FINAL
SUPPLEMENTAL
ENVIRONMENTAL IMPACT REPORT
RANCHO DEL REY SECTIONAL PLANNING AREA
(SPA) III PLAN
EIR #89-10
SCH #90010292

November 1990

CITY OF
CHULA VISTA

Figure 4-2
Grading Plan

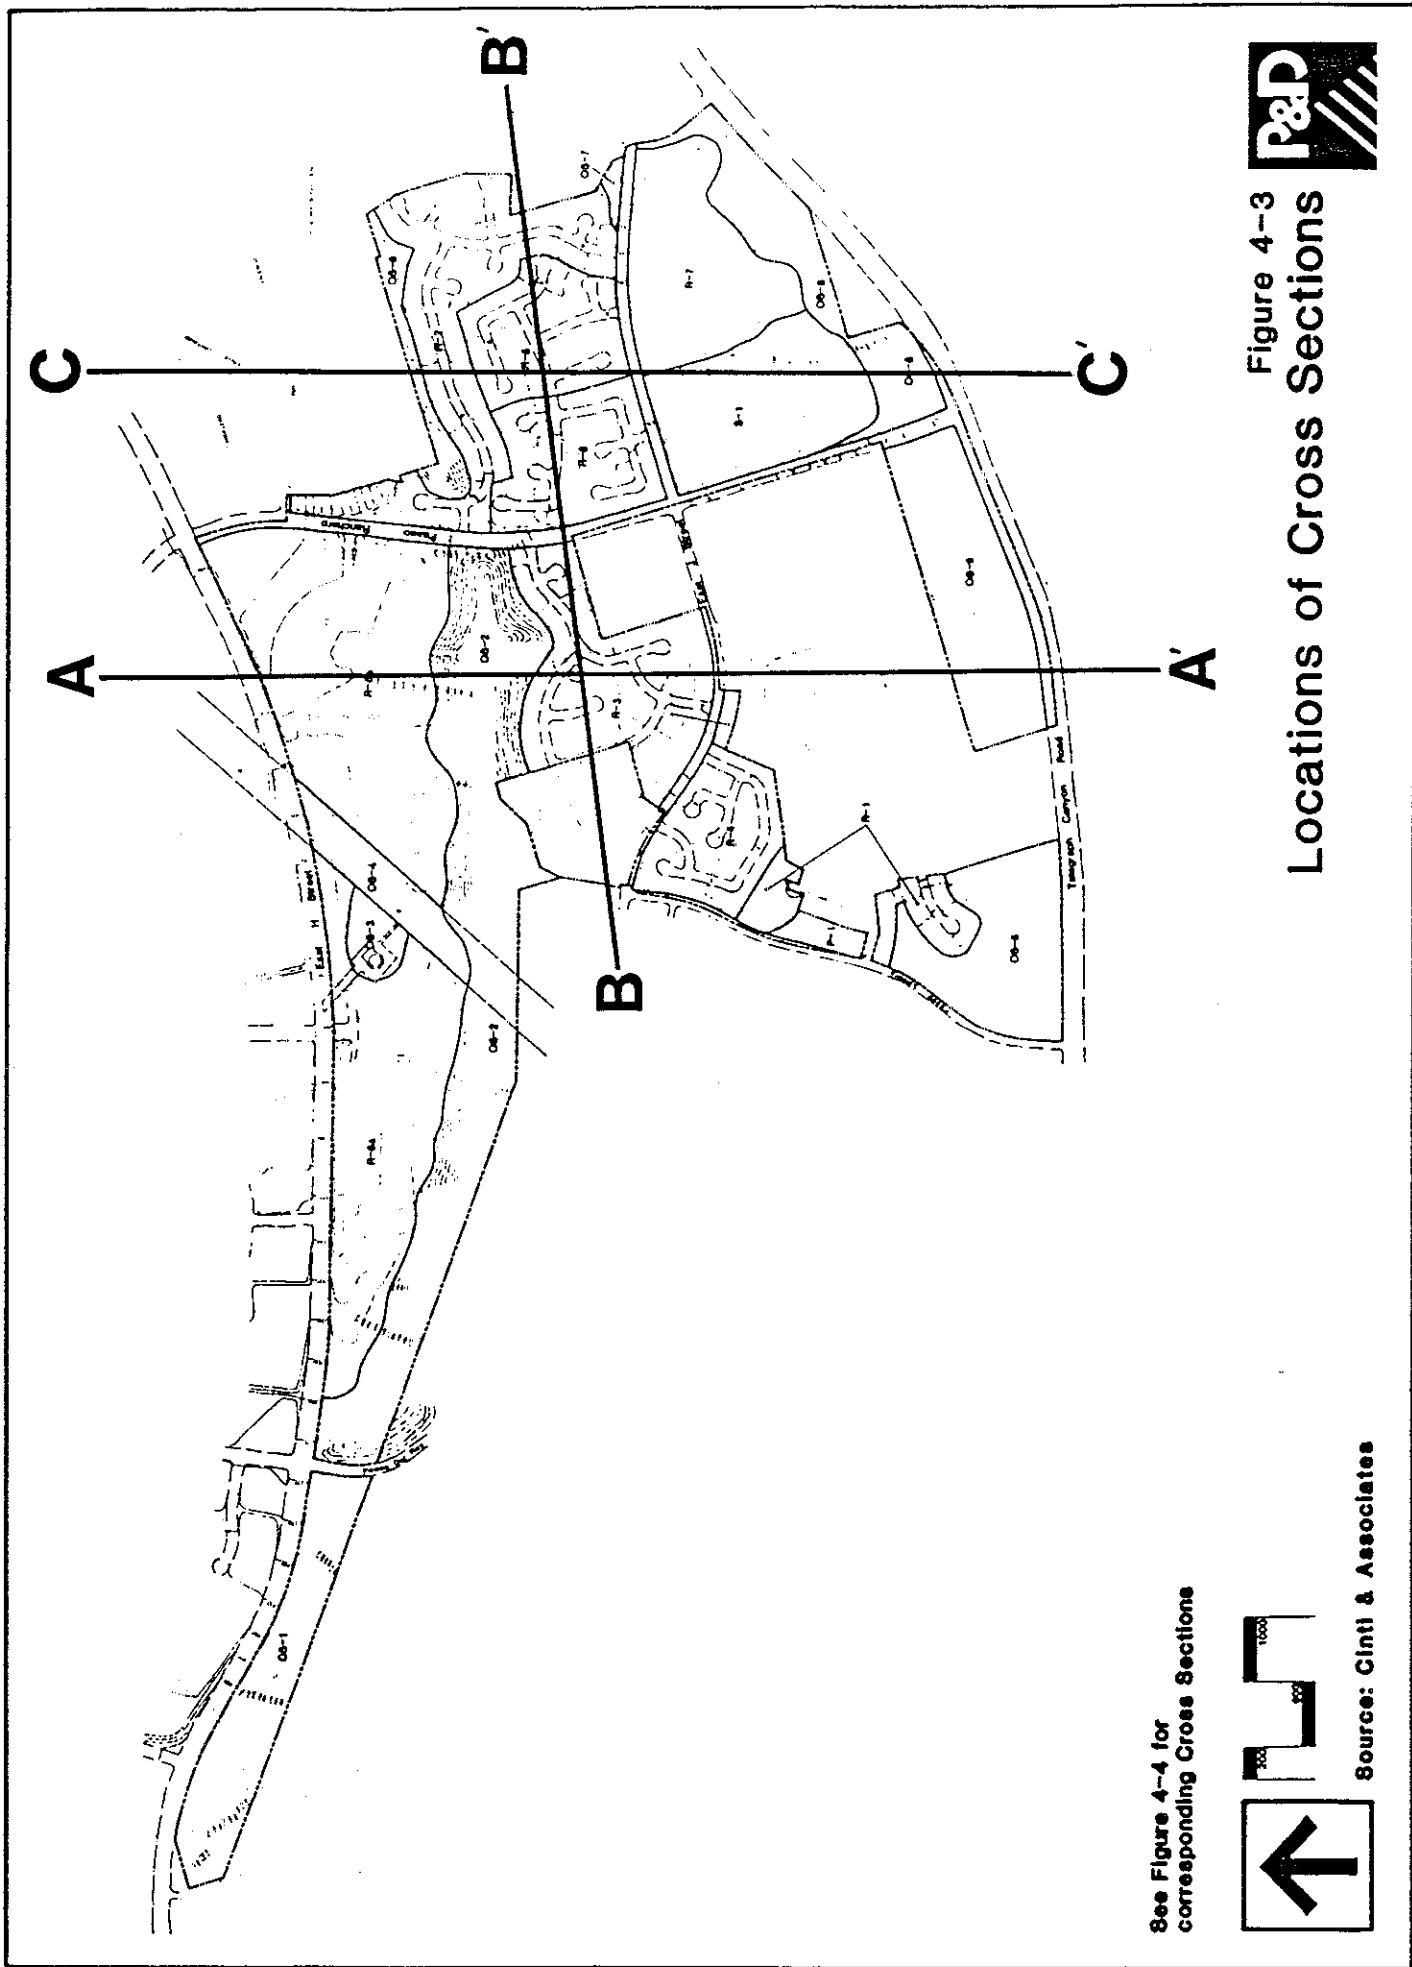
68. 4-14 par. 2, last line. Fill volumes are estimated to be 2.0 to 2.5 million cubic yards.
69. 4-15 Figure 4-2. This is not the proposed Grading Plan, as it shows East "J" Street extended to Buena Vista Way. The proposed Grading Plan is included as Exhibit 14, dated 7/23/90, in the SPA III Plan.
